PROJECT NAME: 23rd Street Paving, Drainage & Utility Rehabilitation

SOLICITATION NO: ITB #B221010

RE: ADDENDUM #1

Prepared By: [Signature]
 Checked By: [Signature]
 DATE: 08/13/21
 PROJECT: GALVESTON COUNTY PAVING, DRAINAGE & UTILITY REHABILITATION WATER & SANITARY PROFILE CROSSINGS SHEET 1 OF 2

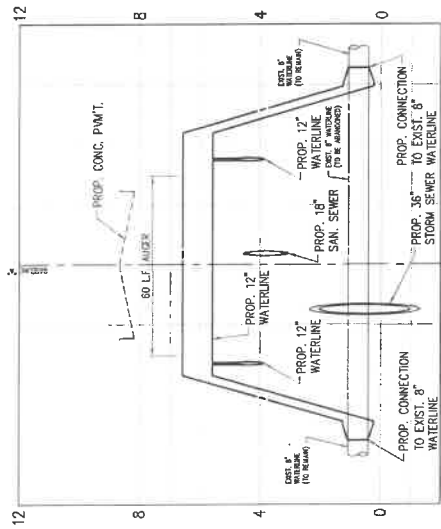
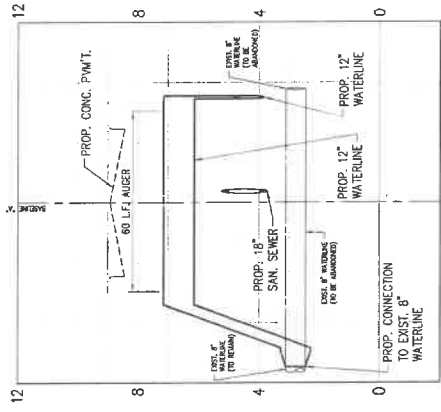
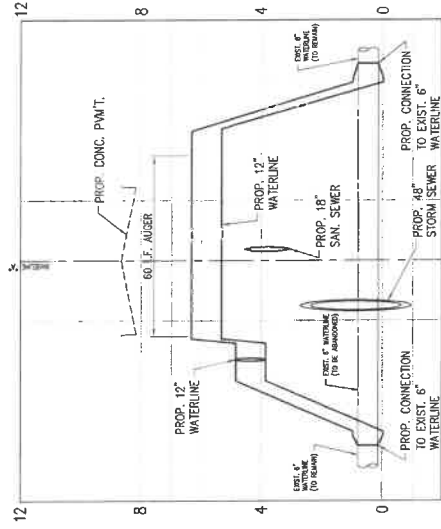
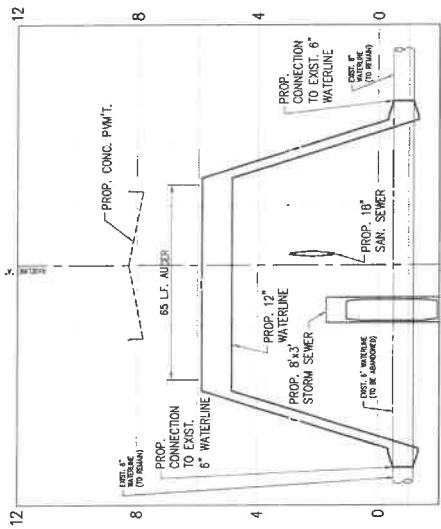
Question #9: *There is only 1,055 LF of augered water line labeled in the plans. Are the lateral offsets intended to be augered as well?*

Response: Yes the lateral offsets are to be included in the augering. A note has been added to the plan set waterline sections and the bid item quantity has been updated.
